NO. DESCRIPTION	BY DATE
SHEET TITLE: PRIVACY EXHIBIT	
PROJECT DESCRIPTION: Coulson Residence 16336 Shady View Ln Los Gatos, CA 95032	
DRAWINGS PROVIDED BY: Delatell Construction, Inc. 1734 THE ASPEN WAY, LOS GATOS, CA 95026 P: (408) 296-7518 F: (408) 296-6599 LIC# B-176485	
DATE: 12/17/2018	
SCALE: As shown	
DRAWN BY: LL / JW	
SHEET: PE

Re: 16336 Shady View Lane Development

Re: 16336 Shady View Lane Development
Date: 09/26/2019
Site Application S-18-060

1 SITE/ROOF PLAN - REDUCED STREET SIDE SETBACK
Scale: 1"=10'

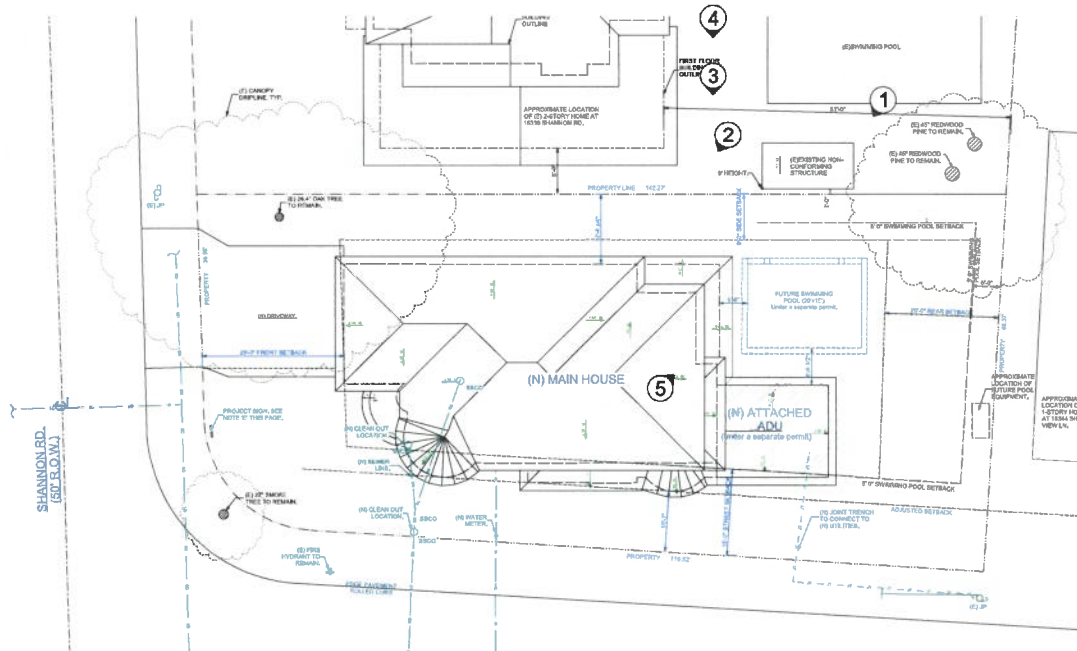
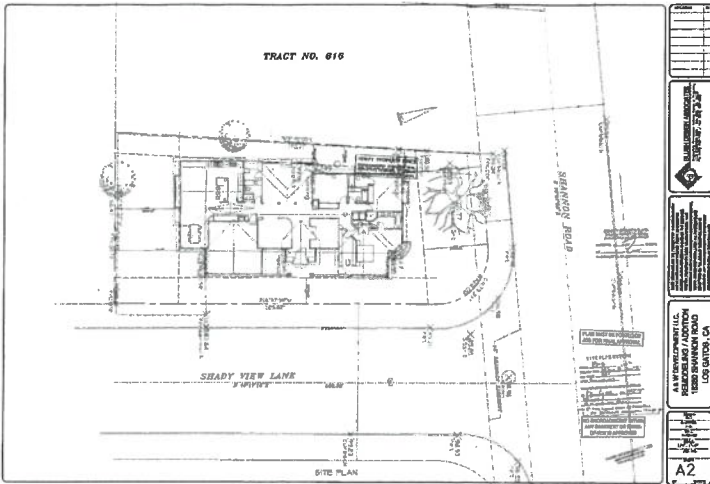
We have been busy looking for creative methods to mitigate our current impasse and feel that we have come up with a solution. In your letters you have voiced your concern regarding the close proximity of the two-story portion of the home. As you know, our options to locate the home are quite limited due to the size and shape of the lot, and thus placed it on the minimum 8'-0" side setback line.

That said, in following with the concept of "Neighborhood Context" and using the reduced street side setback of the home directly across Shady View as precedent, we are proposing to move the home towards Shady View. This will increase the distance between the homes by approximately 4 ½ feet. This change is something that the Town is willing to take under consideration and our hopes are that you will as well.

As you will see in the attached exhibit, views of the home from your yard as well as views on to your property have been improved. We hope that this change in addition to those prior will be acceptable to you in our effort to satisfy your concerns.

1 PROPOSED SECOND FLOOR PLAN
Scale: 1/4"=1'-0"

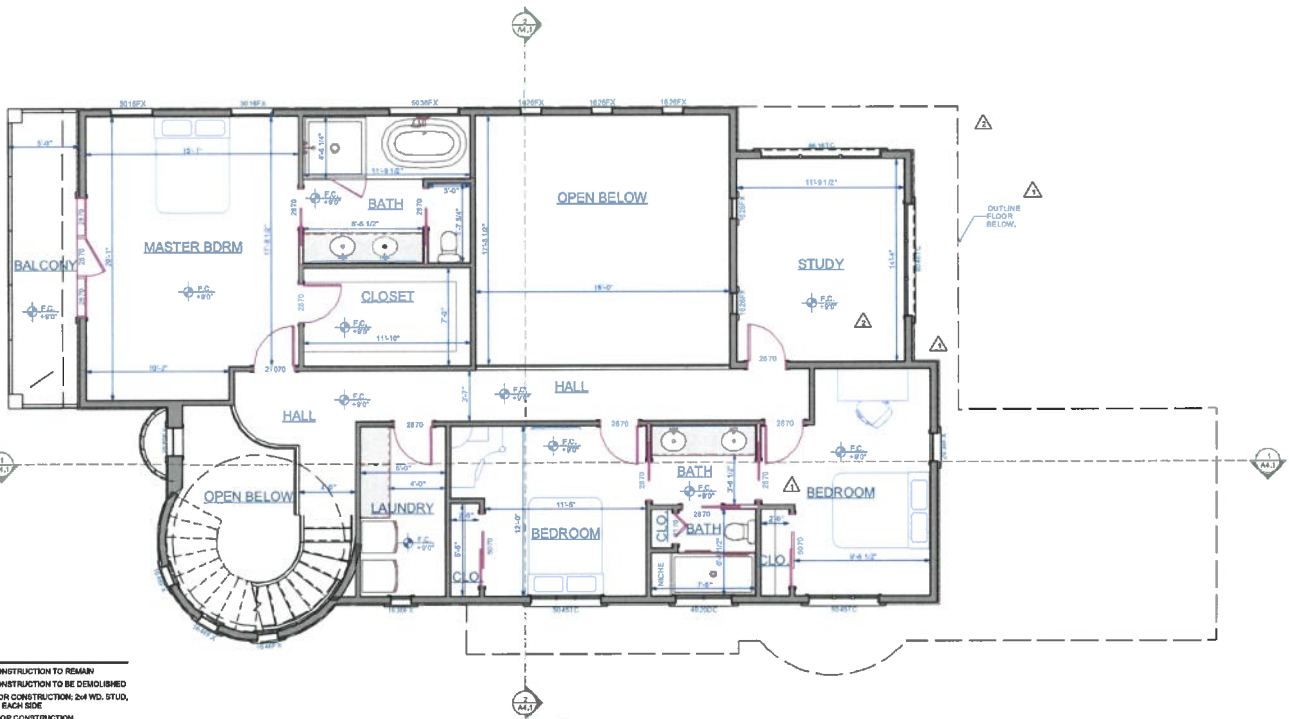
- 1) Please confirm that the applicant continues to be willing to entirely omit the second floor balcony from the project.
- 2) How far is the applicant's new second floor enclosed space/room from the Curries' shared property line?

In further effort to show our willingness to compromise, we have elected to remove the open balcony from the scope of the project. That space is now fully enclosed with very limited views onto our clients own property.
